# HIKIULA GULCH DRAINAGE CHANNEL

# HANAPEPE, KAUAI, HAWAII

ENVIRONMENTAL IMPACT STATEMENT

Letters Received by the
Office of Environmental Quality Control
Regarding the Draft Environmental Impact Statement

Plate 1 - Location of Project

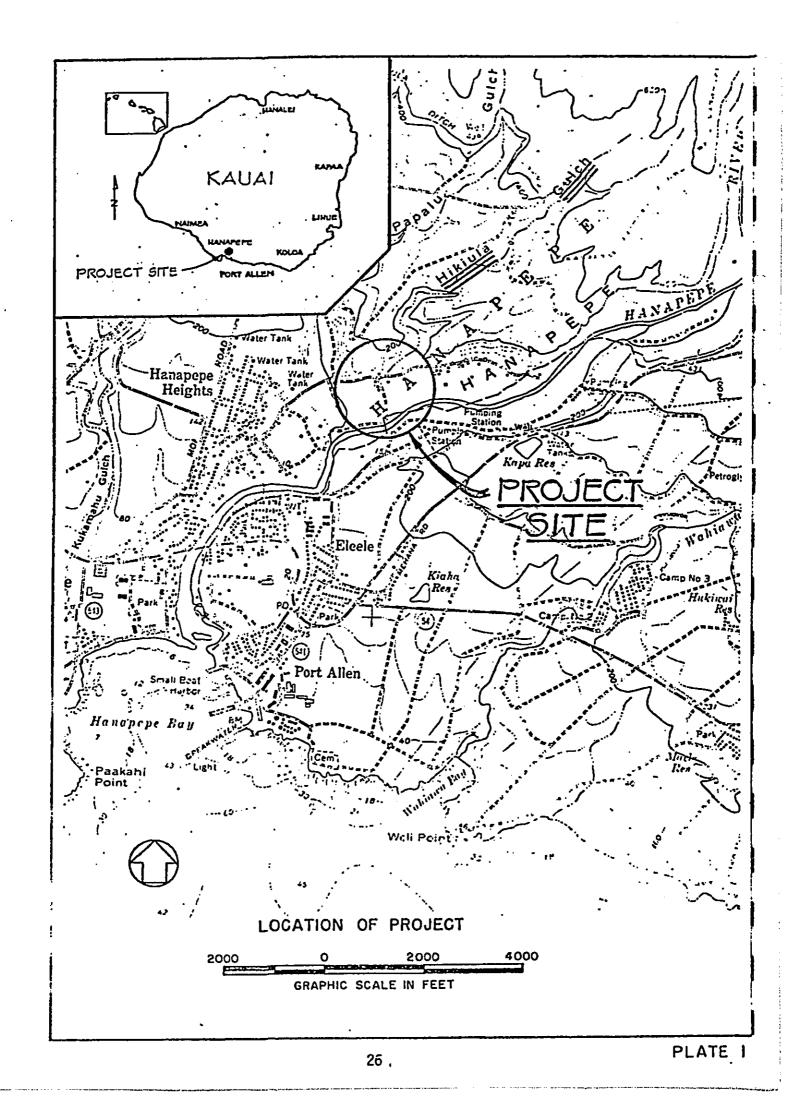
Show access to the project site on the location

Plate 3 - Land Ownership and Use Map

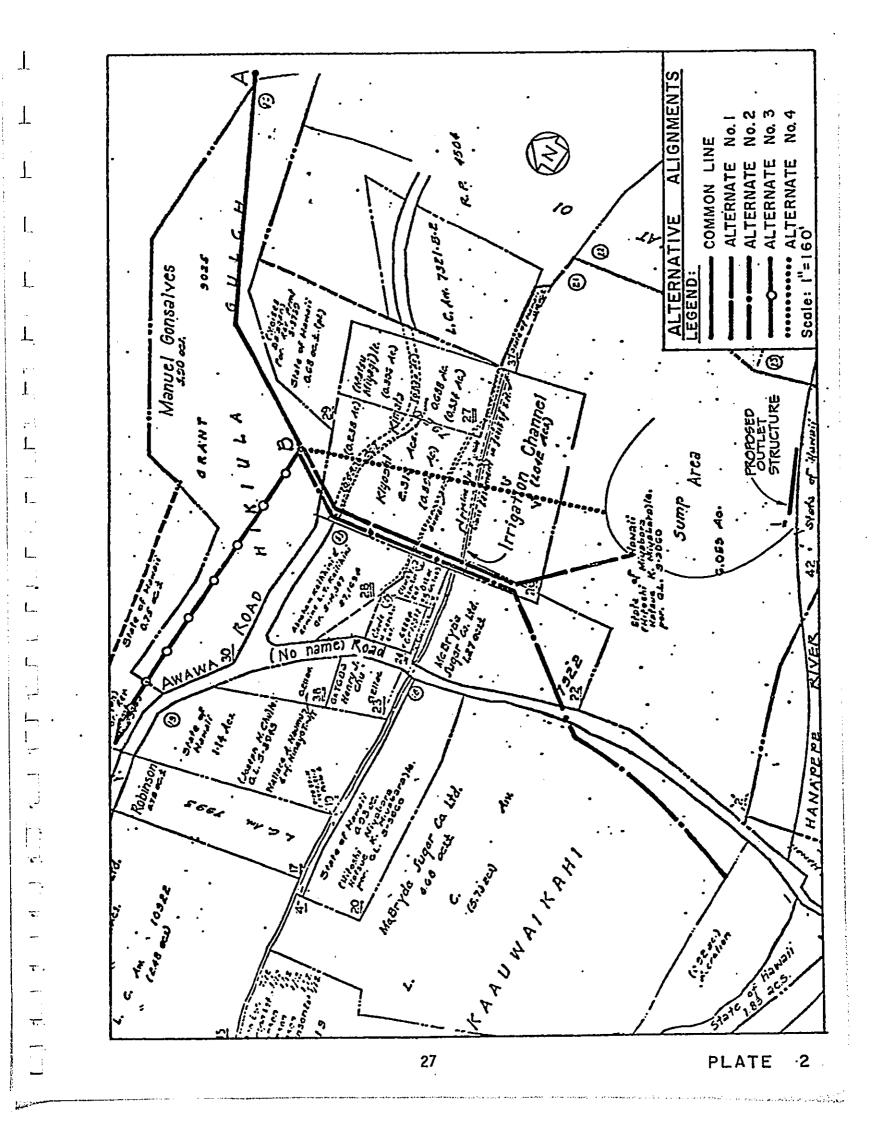
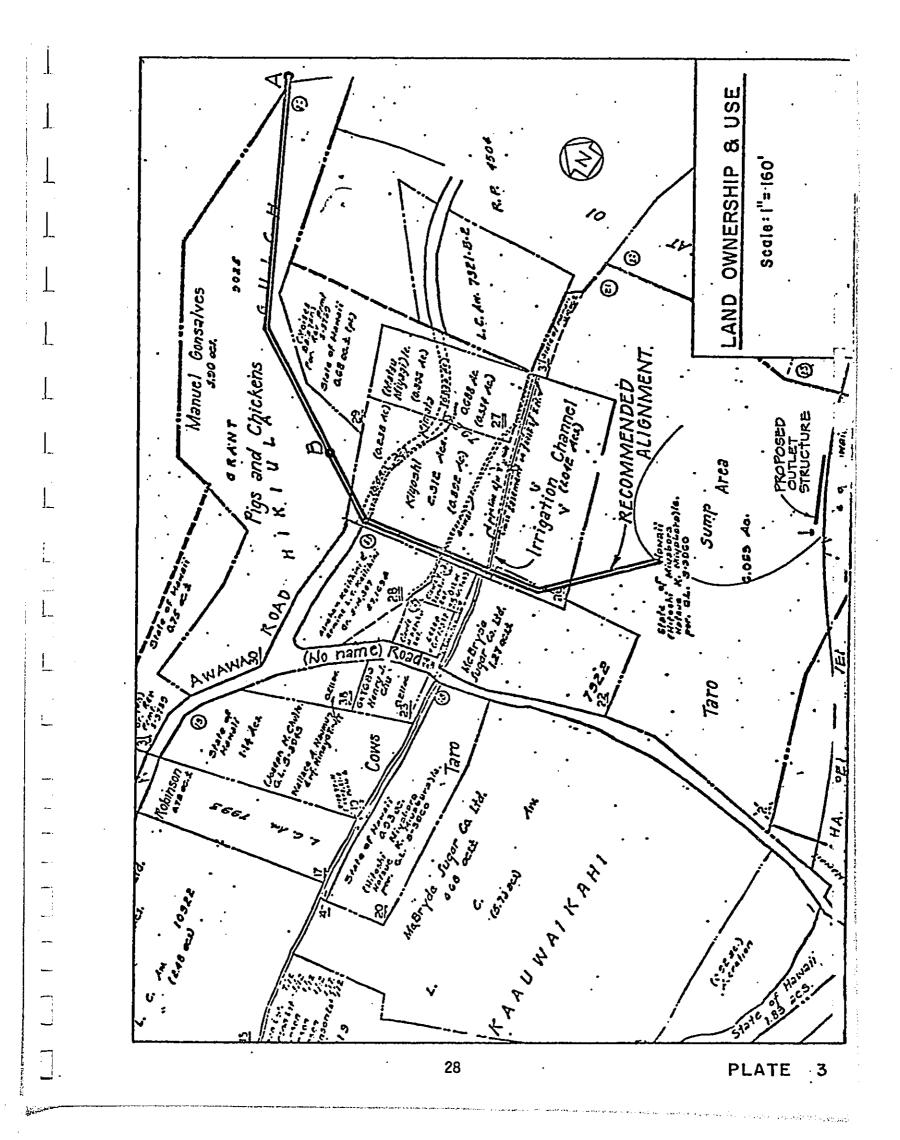
Remove traverse data clutter on figure 1 and 3 and add labeling to clarify work to be done.
